RE: Former Exxon RAS #7-0238/2200 East 12th Street, Oakland California.

June 4, 2007 ERI 229303.W03

Addendum to Work Plan for Additional Soil and Groundwater Investigation

Former Exxon Service Station 7-0238 2200 East 12th Street, Oakland, California

Plate 3:

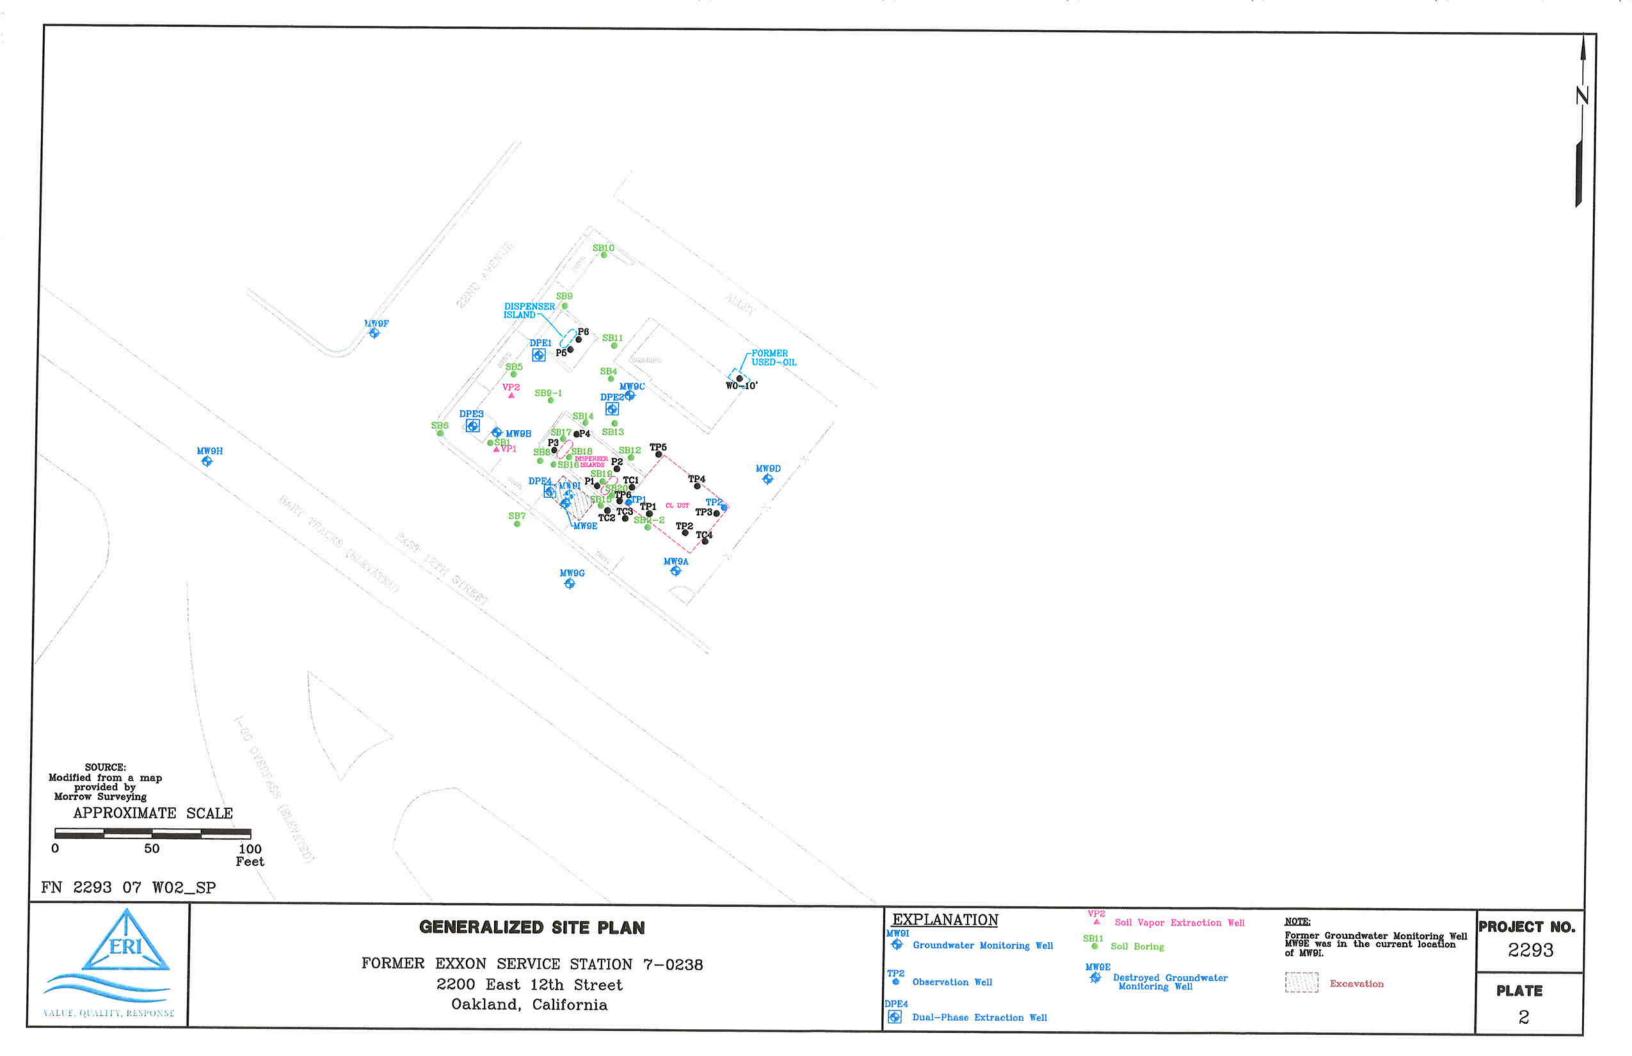
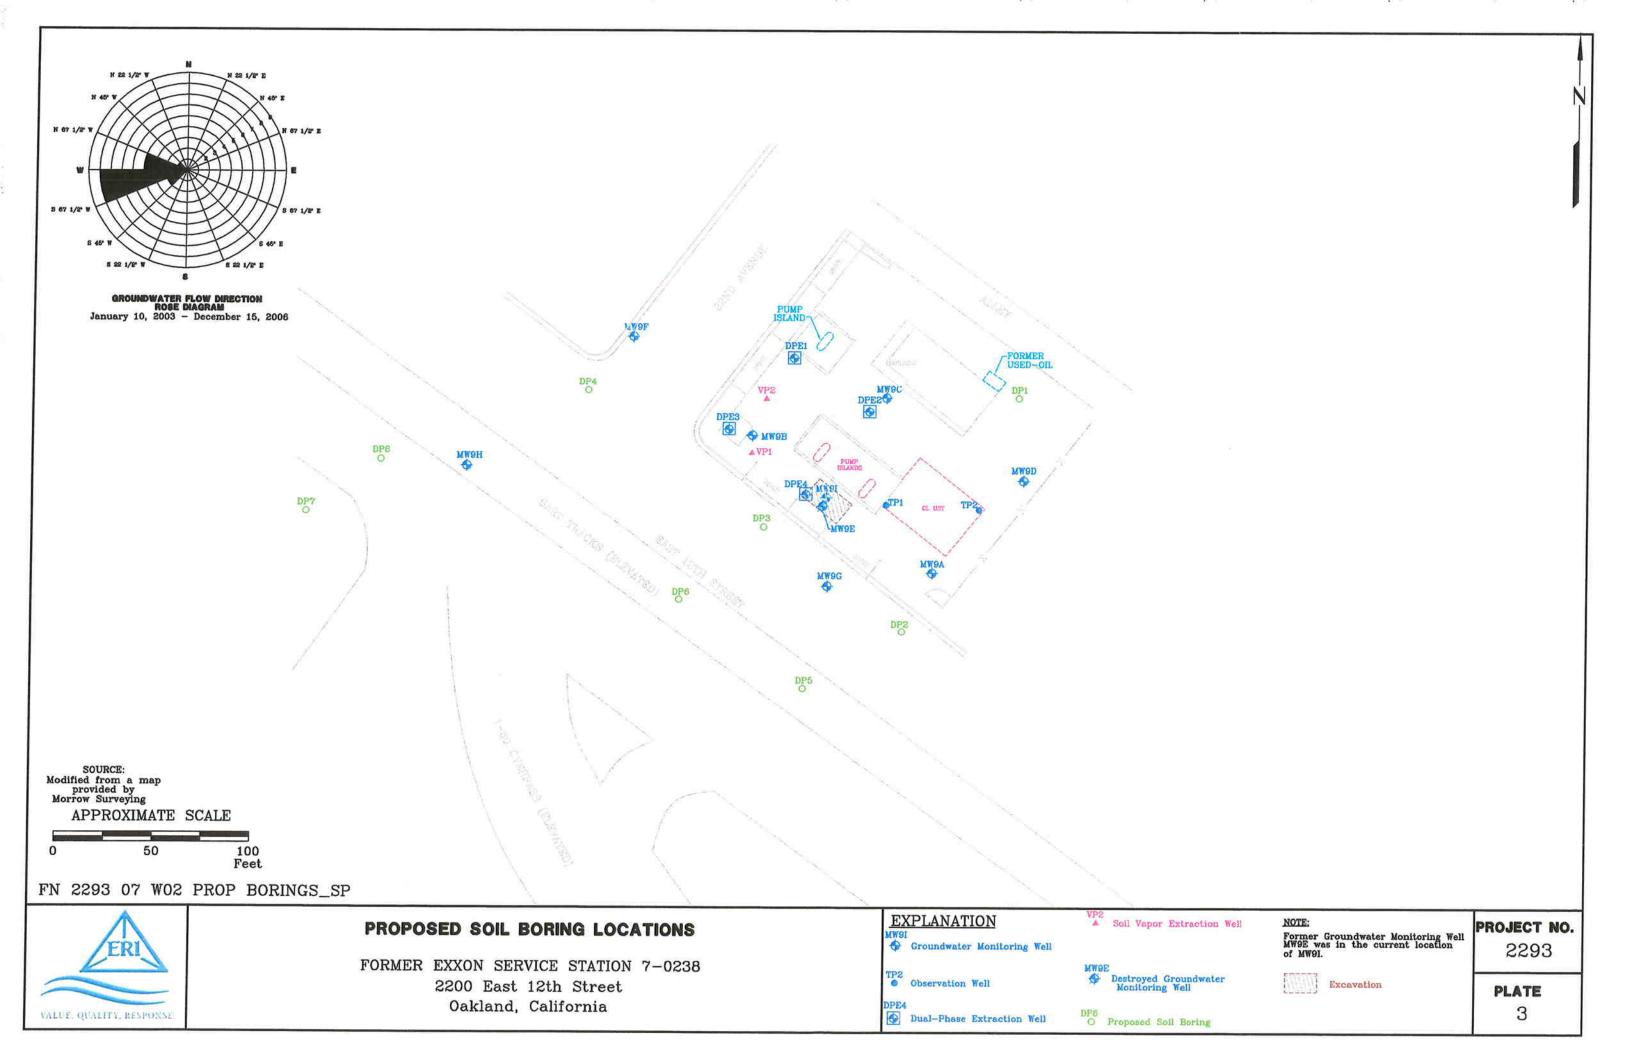
Soil Boring Locations and Sampling: The proposed locations for borings SB12 through SB18 are acceptable; however, a review of historical data indicates that the proposed soil borings have the same ID numbers as soil borings installed in a previous investigation. Please adjust identifiers for your proposed boring locations within the text and on the proposed boring locations figure. Move the location of SB19 to approximately 30-feet northwest of monitoring well MW9H.

- 1. Soil Boring Locations and Sampling. Review of Plate 16 (Proposed Soil Boring Locations) from the Work Plan indicate the proposed soil borings have the same ID numbers as soil borings installed in a previous soil and groundwater investigation. Please rename the soil borings with unique identification numbers to distinguish them from soil borings installed during previous investigations. In addition, ACEH requests that one additional soil boring be located between SB17 and MW9H and soil boring SB19 should be moved from the current location to approximately 30 northwest of MW9H. In addition, ACEH generally agrees with the soil sample analysis recommended in the Work Plan.

Identifiers for proposed boring locations SB12 through SB19 have been changed to DP1 through DP8. The location for SB19 has been adjusted as requested. The adjusted location is shown on Plate 3. The following sections from the Work Plan have been amended to reflect these changes.

Because of interference from crossing subsurface utilities, the location for boring DP4 was moved to the northwest area of the intersection of East 12th Street and 22nd Avenue. Proposed soil boring locations are shown on Plate 3.
